ADDENDUM NO. 5

WESTLAKE SKATE PARK: SITE IMPROVEMENTS

RFP NO. 2024-085

Revisions to Site Plan sht. L2.00
 April 18, 2024
 Scale 1" = 10'

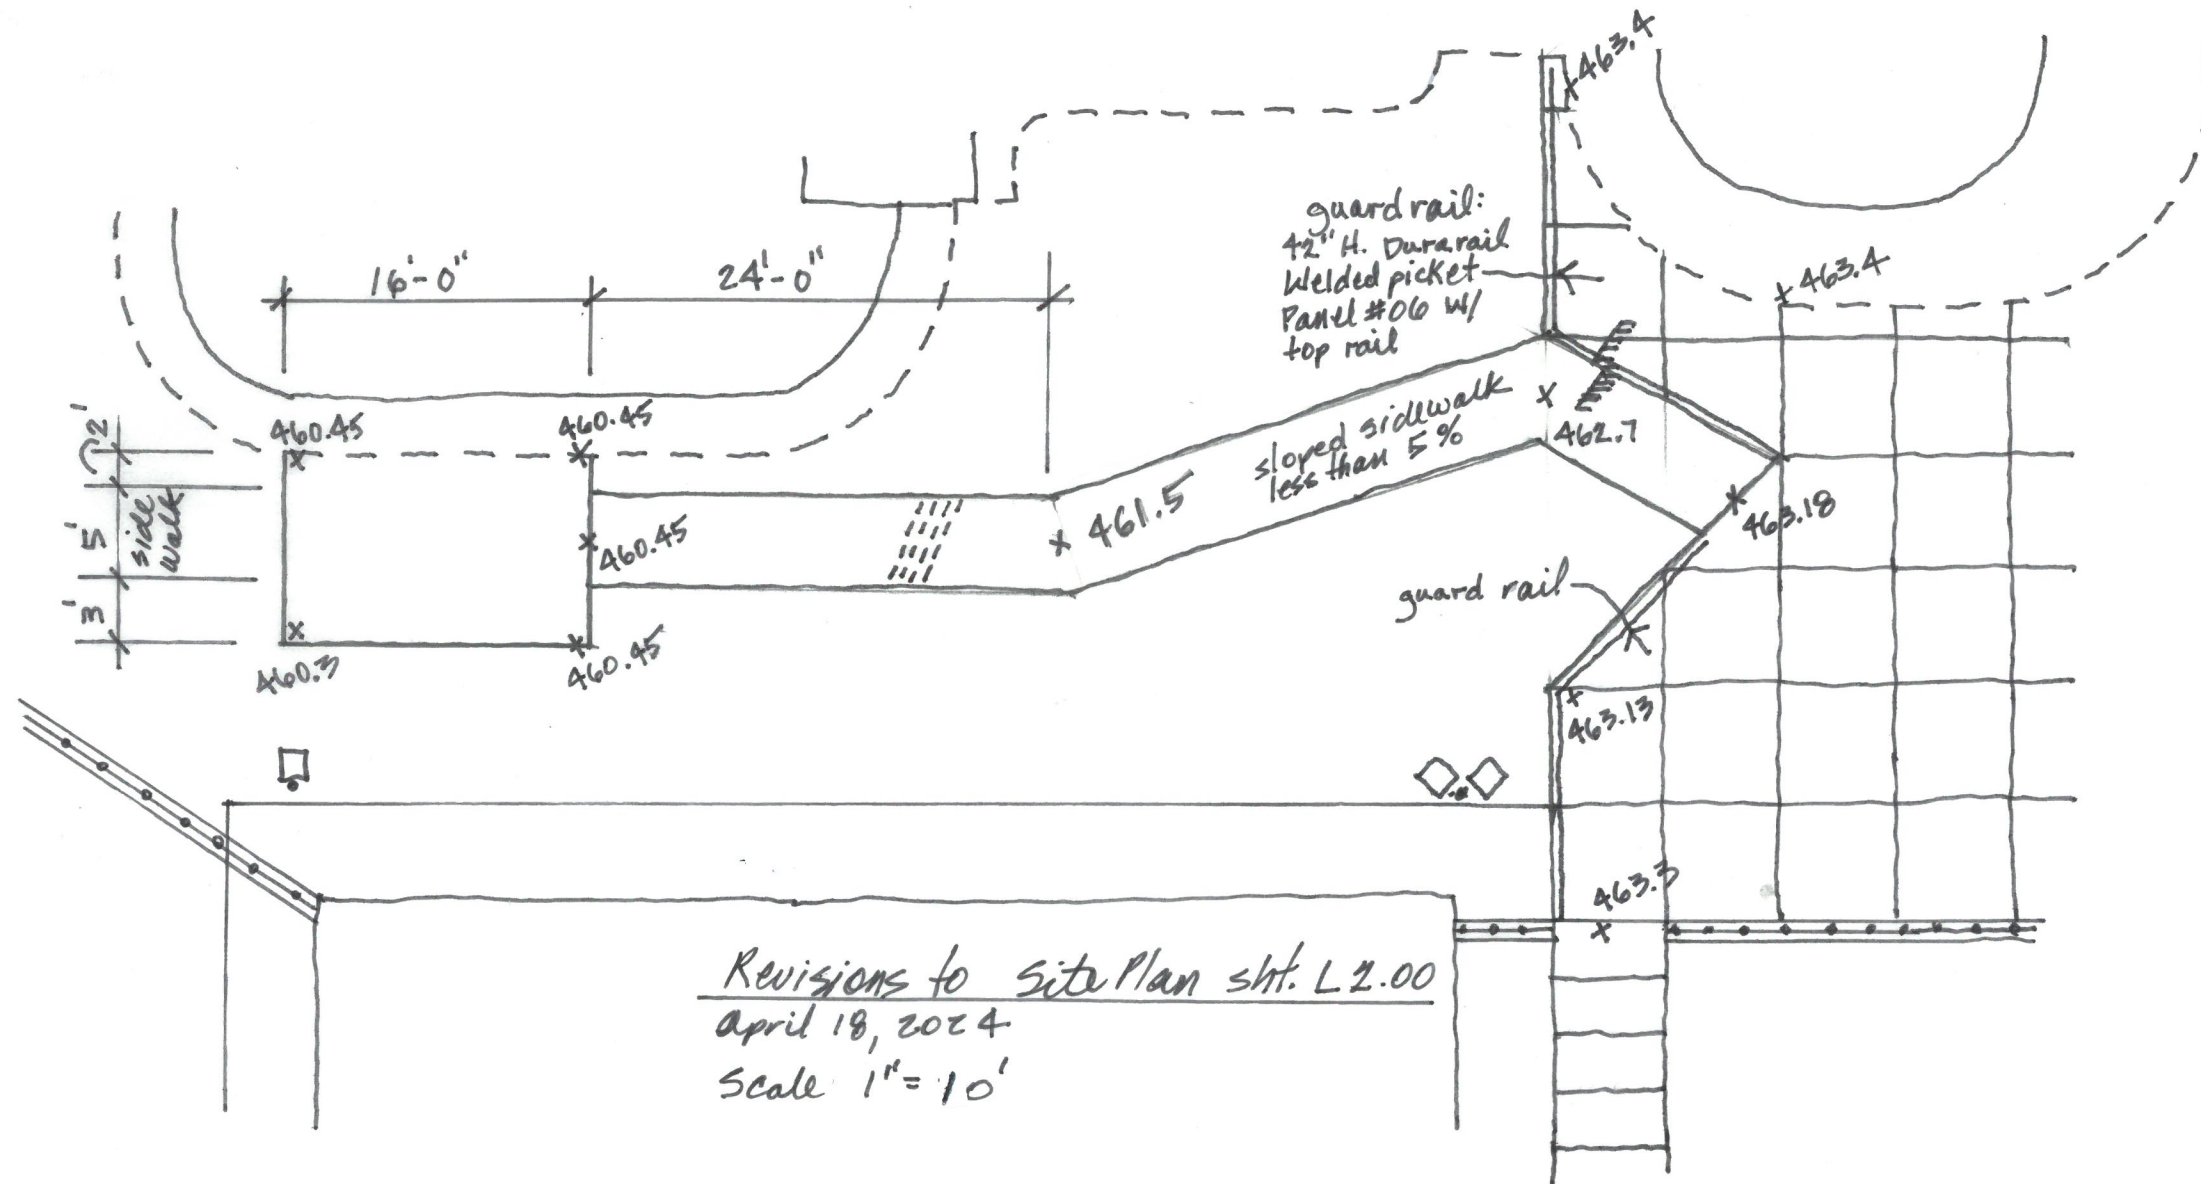
1. Modify the access to the lower level as indicated on the attached exhibit and add guard rail as indicated.
